AQ Matic Valve & Controls Company, Inc.

PERFORMANCE BULLETIN 131

K526 Flange Adapter Consolidation

New 2.5" and 3" Flange Adapter

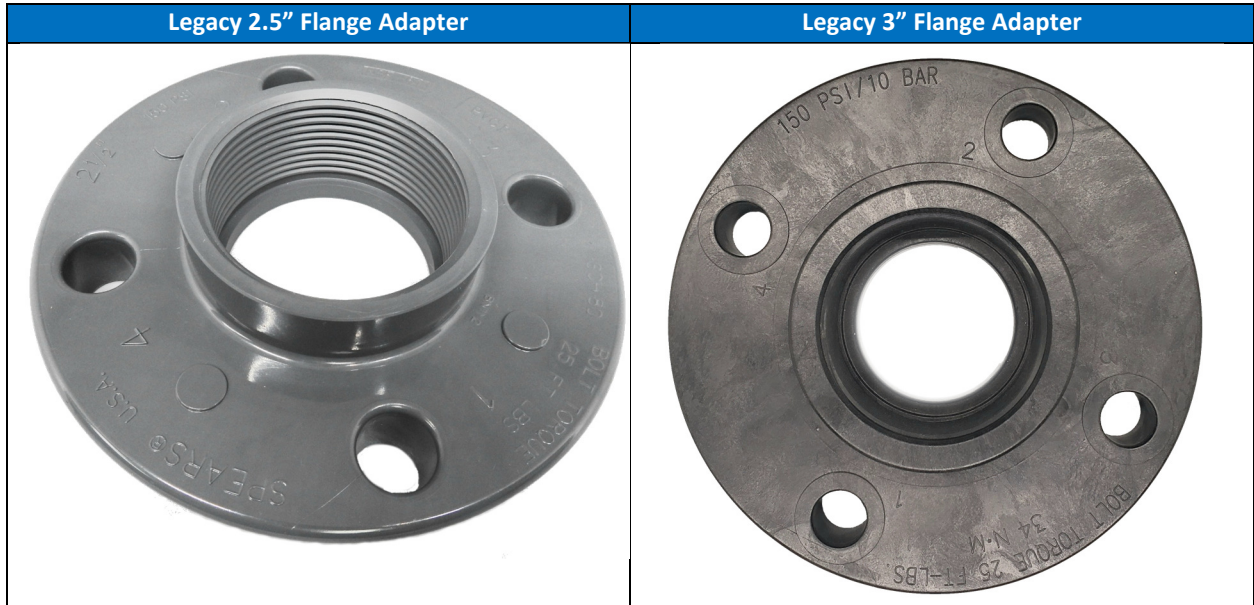
Flange adapters for the K526 valve have been consolidated into one version that can be used in both 2.5" and 3.0" applications. This change has eliminated the need for two separate flange adapters, and now the same Part Number can be stocked regardless of 2.5" or 3.0" connections. Part Number 1070252 KIT,526,2.5"/3.0" FLANGE will now include a set of dual-purpose flanges along with mating orings.

This is a kit acts as a direct replacement to PN 1070251 which was previously the 2.5" kit. Lay length of the valve is unchanged as a result of this update.
